Interactive comment on "GO5.0: The joint NERC-Met Office NEMO global ocean model for use in coupled and forced applications" by A. Megann et al.

A. Megann et al.

Received and published: 6 March 2014

Figure 10. (a) Zonal mean net air–sea heat flux in GO1 (black); GO5.0 (red) and CORE2 data (dashed blue line) in years 1996-2005; and (b) surface net downward heat flux difference GO5.0 minus GO1.

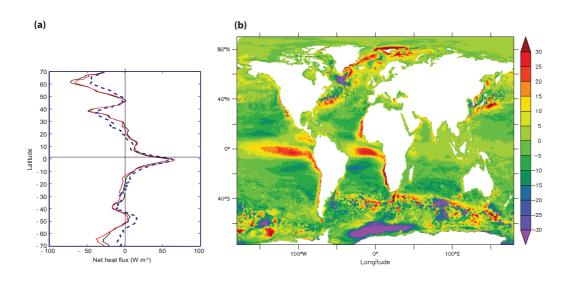
"The paper focus on the surface layer and there is in the text few comments or remarks about the atmospheric forcing, I suggest adding some figures to illustrate impact of the atmospheric forcing which is the main driver of the ocean and which can explain lot of bias discussed in the paper. For example, it will be useful to know how the surface fluxes, computed with the bulk formulae, are impacted in the experiments. Do we have a large difference in the mean fluxes between GO1 and GO5.0?".

P5764 I28: You write that there is no atmosphere ocean feedback in your simulation. As you use bulk formulae there is a feedback and it will be useful to illustrate flux differences between the simulations.

We have added an extra figure (Fig. 10) showing zonal mean heat fluxes from GO1 C2781

and GO5.0 alongside those from the CORE2 dataset, and the 2-D surface difference in the fluxes between GO1 and GO5.0, as well as an extra subsection (5.2.3) discussing them.

The changed surface flux does not correspond to any change in surface air temperature, but we acknowledge that there is limited feedback in the form of a damping term towards the surface air temperature, rather than a true feedback. In this sense the surface flux error diagnoses the tendency of the model to drift away from the climatological SST. We have inserted a new figure (Figure 10) showing the zonal mean heat fluxes and the difference in surface heat flux between GO1 and GO5 and added a subsection (5.2.3) discussing this.
